Item ID: 646.3716 Accept ***N900040100*** Setup Start ***NS1***
Revision ID: Stop ***NS2***
Item Name: Gauge Bracket
Start Date: 1/25/2017 Start Qty: 10.00 ***10*** Cust Item ID:
Required Date: 2/10/2017 Req'd Qty: 10.00 ***10*** Customer:
Reference:

APICAL INDUSTRIES, INC.	ENGINEERING CHANGE NOTICE NO. 03702				SHEET 1	
	DWG NO. 646.3700	REV: A	PREPARED BY B. PETERS	DATE: 11/15/12	EFF: ☐	
	DWG TITLE: SHEETMETAL					
APPROVED BY: ENGR <i>[Signature]</i>		MFG <i>[Signature]</i>	QC <i>[Signature]</i>	EFF: NEXT		
TRANSACTION CODES (TC): A-ADD C-CREATE R-REVISE D-DELETE		REASON: ADDED ALTERNATE MATERIAL AND REVISED REFERENCE DIMENSIONS				EOR: D-12-010

QTY	FND #	PART #	DESCRIPTION	MAT L	SPEC.
		646.3719	DOUBLER		
		646.3718	CUSTOM WASHER		
		646.3717	DOUBLER		
		646.3716	GAUGE BRACKET		
		646.3715	DOUBLER		
		646.3714	GUSSET		
		646.3713	GUSSET		
		646.3712	CLIP		
		646.3711	CLIP		
		646.3710	DOUBLER		
PARTS LIST					
NEXT ASSY (S)			APICAL INDUSTRIES		
646 4000			2608 TEMPLE HEIGHTS DR.		
			OCEANSIDE, CA. 92056-3512 (760)724-5300		
			SHEETMETAL		
			STL C-41 CODE	DWG NO	REV
			B 07M76	646.3700	A
			SCALE NONE		
			SHEET 1 OF 9

SHEET 1, ZONE A2 IS:

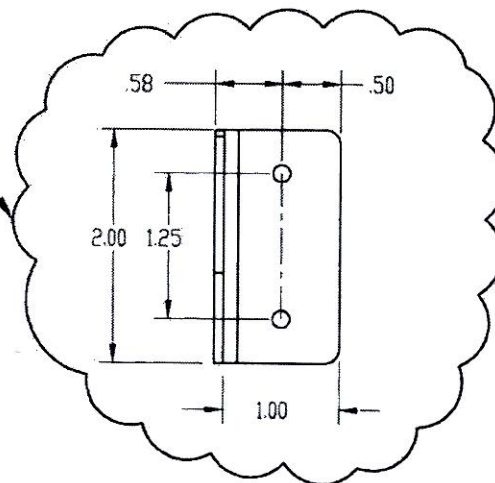
△ PRIMARY MATERIAL: ALUMINUM 6061-T6 PER AMS-QQ-A-2
ALTERNATE MATERIAL: SS 17-4 PH PER AMS 5604
